**MODIFICATION 01 - JUNE 2020**  
**SCHEDULE OF CHANGES**

32 The Strand Whale Beach				
SUMMARY OF BASIX COMMITMENTS				
This is a summary of the BASIX Commitments as detailed in the BASIX Certificate. Refer to the CURRENT BASIX Certificate for Complete details. For definitions refer to basix.nsw.gov.au				
WATER COMMITMENTS				
Fixtures				
3 Star Shower Heads		Yes ( > 4.5 but <= 6 L/min)		
5 Star Kitchen / Basin Taps		Yes	4 Star Toilet	Yes
Alternative Water				
Minimum Tank Size (L)		3000	Collected from Roof Area (m2)	70
Tank Connected To:				
All Toilets		Yes	Laundry W/M Cold Tap	Yes
One Outdoor Tap		Yes		
THERMAL COMFORT COMMITMENTS - Refer to TPA Specification on plans				
ENERGY COMMITMENTS				
Hot Water		Solar (Electric Boost) 21 to 25 STCs		
Cooling System	Living	1 Phase A/C Zoned		EER 2.5 - 3.0
	Bedrooms	1 Phase A/C Zoned		EER 2.5 - 3.0
Heating System	Living	1 Phase A/C Zoned		EER 2.5 - 3.0
	Bedrooms	1 Phase A/C Zoned		EER 2.5 - 3.0
Ventilation	1 x Bathroom	Fan ducted to exterior		Manual on/off

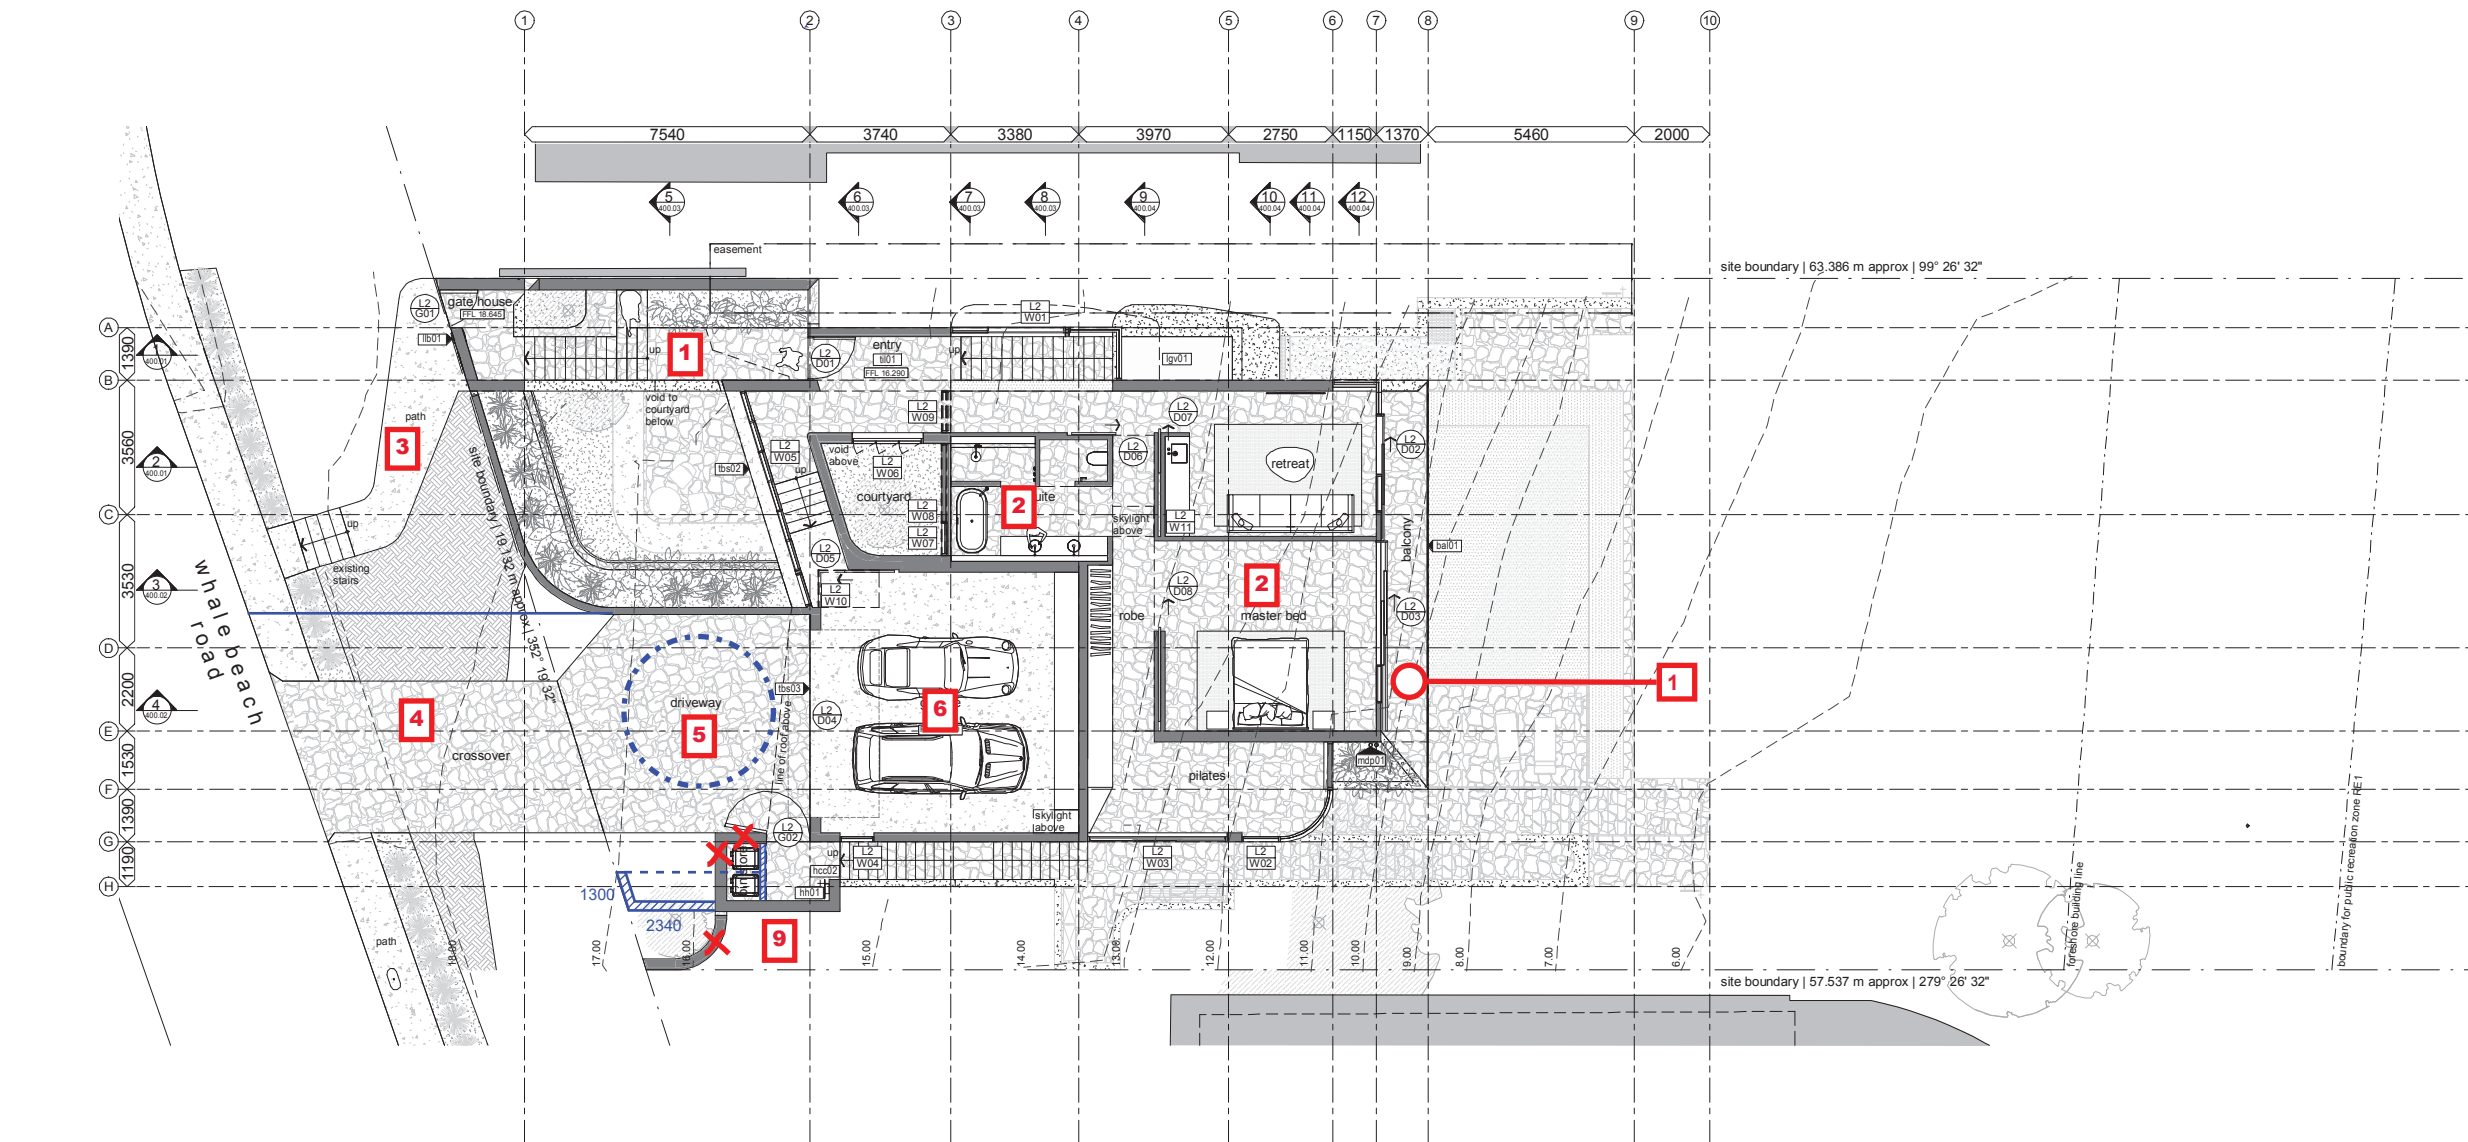
- Typical to all external areas: stone floor paving substituted for conventional shaped natural stone tile
- Typical to all internal areas: stone floor paving substituted for timber floors, and conventional shaped natural stone tiles in wet areas

- Hard path and steps removed from architectural scope. Soft landscaping solution by landscape architect
- Driveway finish changed and widened in accordance with consent SL2020/0241

- Driveway levels modified to suit Council requirements in accordance with consent SL2020/0241. Car turntable added
- Garage level raised by 300mm to RL17.700 as a result of accommodating [5]

- Garage roof and garden edge lifted 150mm to RL20.850 as a result of accommodating [5] and [6].
- Main roof ridge lowered by 290mm to RL22.750 as a courtesy to improve the view amenity of a neighbour to the west. Roof slope adjusted to 11.6 degrees.

- Bin store reshaped and curved wall deleted. Bin store lid level shown at RL20.150. Refer to plans for dims where appropriate. Alteration in part as a result of compliance with prescribed conditions of consent (23) + (25) relating to tree protection and arborist's recommendations.

- Minor alteration to configuration of glazing. Fixed glass to study. Glazed swing door out of laundry. Note net area and amount of glass remains unchanged.

- Minor alteration to configuration of glazing. Refer to plan for relocation of walls. Note net area and amount of glass remains unchanged. floor area slightly reduced.

- Swimming pool infinity edges (and associated ballast tank) deleted and zone changed to accessible path and landscaped wall/planter
- Steps introduced to pool terrace to access service path. Refer to plans for dims where appropriate.

- Extra solar panels added to increase energy efficiency of development
- Block wall moved down to align with pool equipment adjacent as shown. Note this change is underground and not visible to the public or neighbours.

- Plant and equipment store area increased by moving western wall further west in order to accommodate the required equipment with ventilation and service space. Refer to plans for dims where appropriate.

- Block wall to be changed to screening for ventilation and sound attenuation
- Seat added
- Landscape plan amended in accordance with prescribed conditions of consent (15) + (38).

- Height of landscaped wall facing street to be increased to the North to a max height of 1800mm above ground level to follow natural topography.

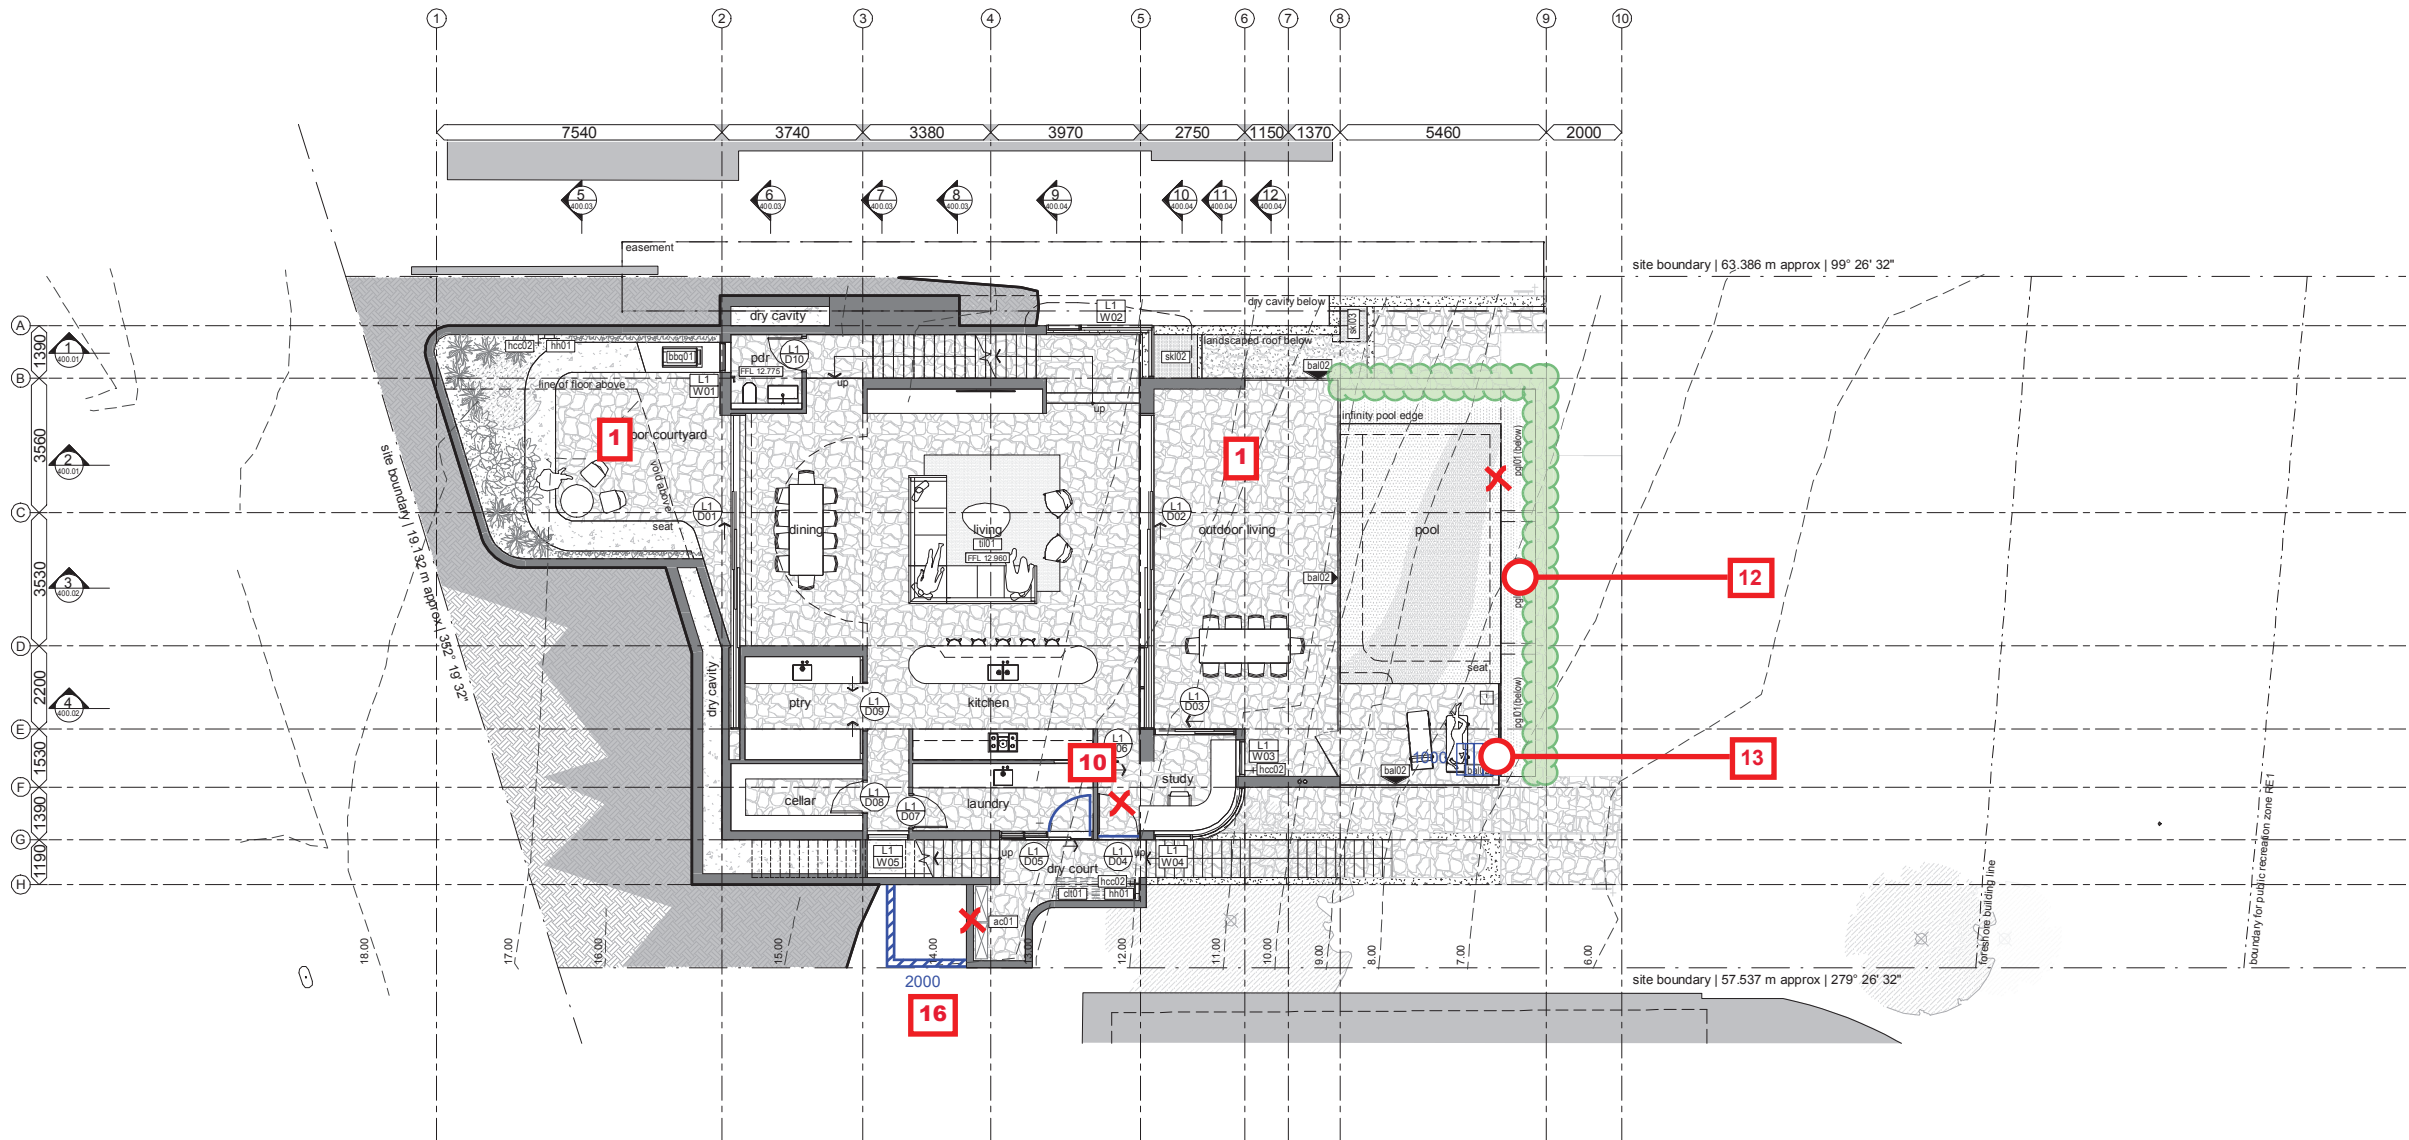
1. Typical to all external areas: stone floor paving substituted for conventional shaped natural stone tile
2. Typical to all internal areas: stone floor paving substituted for timber floors, and conventional shaped natural stone tiles in wet areas

3. Hard path and steps removed from architectural scope. Soft landscaping solution by landscape architect
4. Driveway finish changed and widened in accordance with consent SL2020/0241

5. Driveway levels modified to suit Council requirements in accordance with consent SL2020/0241. Car turntable added
6. Garage level raised by 300mm to RL17.700 as a result of accommodating [5]

7. Garage roof and garden edge lifted 150mm to RL20.850 as a result of accommodating [5] and [6].
8. Main roof ridge lowered by 290mm to RL22.750 as a courtesy to improve the view amenity of a neighbour to the west. Roof slope adjusted to 11.6 degrees.

9. Bin store reshaped and curved wall deleted. Bin store lid level shown at RL20.150. Refer to plans for dims where appropriate. Alteration in part as a result of compliance with prescribed conditions of consent (23) + (25) relating to tree protection and arborist's recommendations.

10. Minor alteration to configuration of glazing. Fixed glass to study. Glazed swing door out of laundry. Note net area and amount of glass remains unchanged.

11. Minor alteration to configuration of glazing. Refer to plan for relocation of walls. Note net area and amount of glass remains unchanged. floor area slightly reduced.

12. Swimming pool infinity edges (and associated ballast tank) deleted and zone changed to accessible path and landscaped wall/planter
13. Steps introduced to pool terrace to access service path. Refer to plans for dims where appropriate.

14. Extra solar panels added to increase energy efficiency of development
15. Block wall moved down to align with pool equipment adjacent as shown. Note this change is underground and not visible to the public or neighbours.

16. Plant and equipment store area increased by moving western wall further west in order to accommodate the required equipment with ventilation and service space. Refer to plans for dims where appropriate.

17. Block wall to be changed to screening for ventilation and sound attenuation
18. Seat added
19. Landscape plan amended in accordance with prescribed conditions of consent (15) + (38).

20. Height of landscaped wall facing street to be increased to the North to a max height of 1800mm above ground level to follow natural topography.

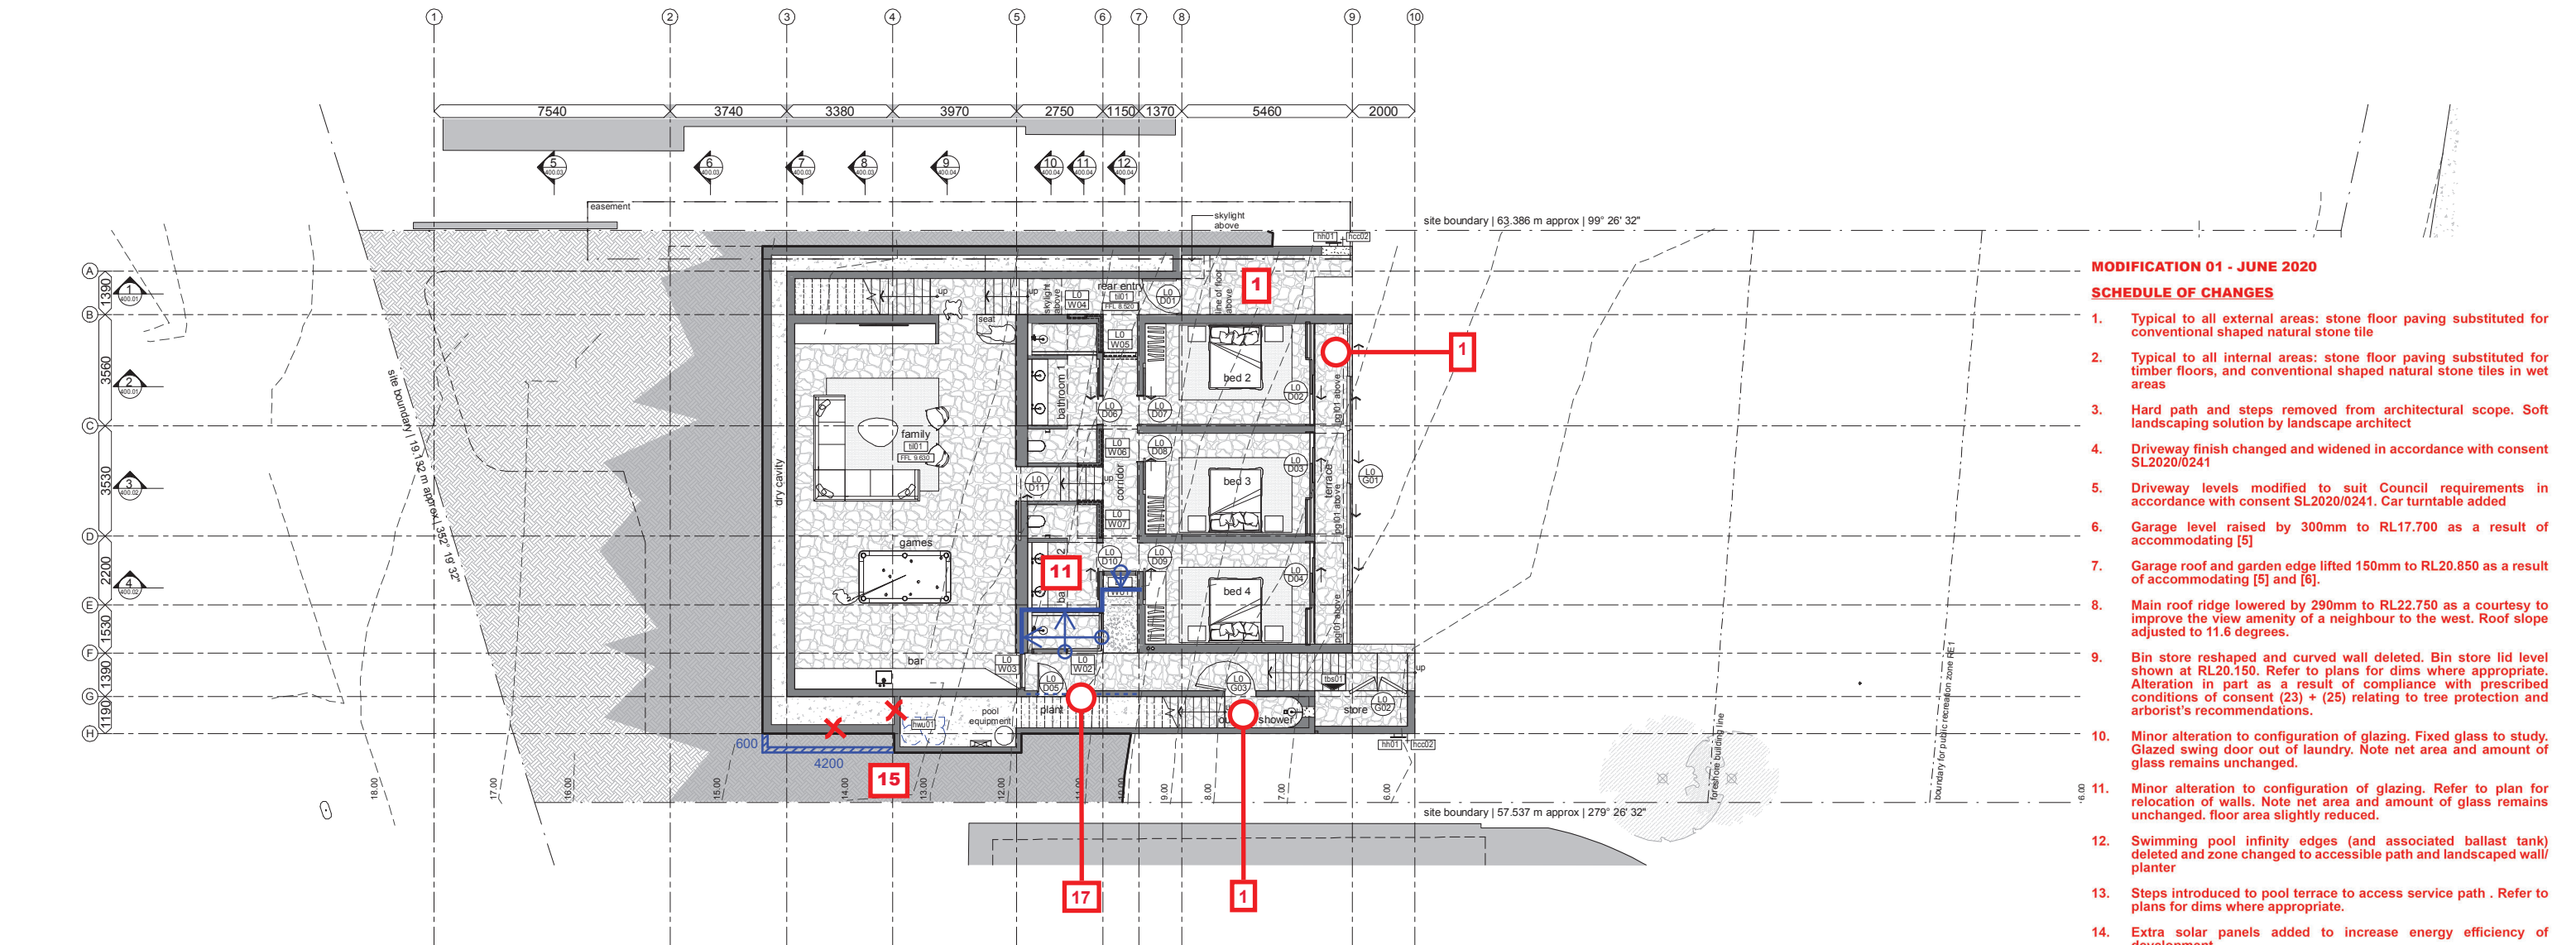
1. Typical to all external areas: stone floor paving substituted for conventional shaped natural stone tile
2. Typical to all internal areas: stone floor paving substituted for timber floors, and conventional shaped natural stone tiles in wet areas

3. Hard path and steps removed from architectural scope. Soft landscaping solution by landscape architect
4. Driveway finish changed and widened in accordance with consent SL2020/0241

5. Driveway levels modified to suit Council requirements in accordance with consent SL2020/0241. Car turntable added
6. Garage level raised by 300mm to RL17.700 as a result of accommodating [5]

7. Garage roof and garden edge lifted 150mm to RL20.850 as a result of accommodating [5] and [6].
8. Main roof ridge lowered by 290mm to RL22.750 as a courtesy to improve the view amenity of a neighbour to the west. Roof slope adjusted to 11.6 degrees.

9. Bin store reshaped and curved wall deleted. Bin store lid level shown at RL20.150. Refer to plans for dims where appropriate. Alteration in part as a result of compliance with prescribed conditions of consent (23) + (25) relating to tree protection and arborist's recommendations.

10. Minor alteration to configuration of glazing. Fixed glass to study. Glazed swing door out of laundry. Note net area and amount of glass remains unchanged.

11. Minor alteration to configuration of glazing. Refer to plan for relocation of walls. Note net area and amount of glass remains unchanged. floor area slightly reduced.

12. Swimming pool infinity edges (and associated ballast tank) deleted and zone changed to accessible path and landscaped wall/planter
13. Steps introduced to pool terrace to access service path . Refer to plans for dims where appropriate.

14. Extra solar panels added to increase energy efficiency of development
15. Block wall moved down to align with pool equipment adjacent as shown. Note this change is underground and not visible to the public or neighbours.

16. Plant and equipment store area increased by moving western wall further west in order to accommodate the required equipment with ventilation and service space. Refer to plans for dims where appropriate.

17. Block wall to be changed to screening for ventilation and sound attenuation
18. Seat added
19. Landscape plan amended in accordance with prescribed conditions of consent (15) + (38).

20. Height of landscaped wall facing street to be increased to the North to a max height of 1800mm above ground level to follow natural topography.
